Appln No. 10/758,762
Amdt date April 28, 2006
Reply to Office action of January 30, 2006

REMARKS/ARGUMENTS

Amendments to the Drawings

FIG. 12

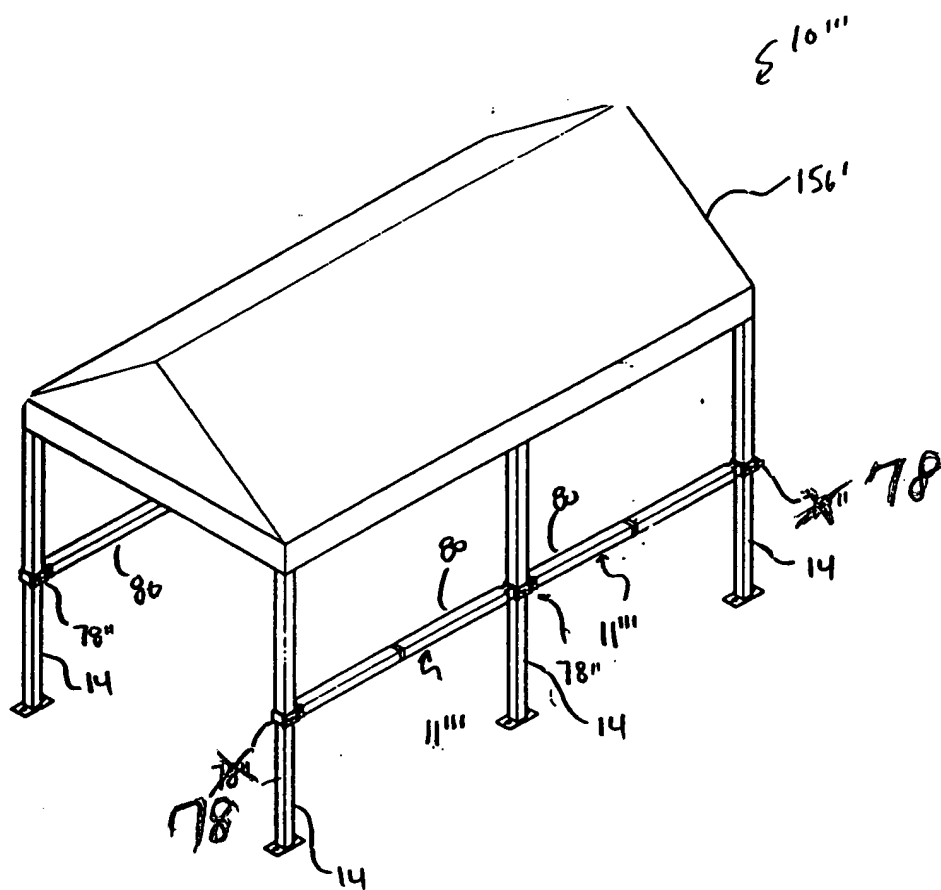
The Examiner has objected to the drawings under 37 CFR §1.84(l) and §1.84(u)(2) because the view numbers are not larger than the reference characters and because the lines on the drawings are not sufficiently dense, dark, uniformly thick and well-defined. The Examiner has further objected to the drawings specifically because reference character 28' in Figure 12 should be labeled 128' for consistency and because reference characters for the mounting brackets at the ends of the posts in Figure 16 should be labeled 78 rather than 78". Applicant has amended the drawings and requests that the objections to the drawings be withdrawn.

The attached 2 sheets of annotated drawings include changes to FIGs. 12 and 16. The attached 12 sheets of replacement drawings, which include FIGs. 1-16, replace the original drawings as filed.
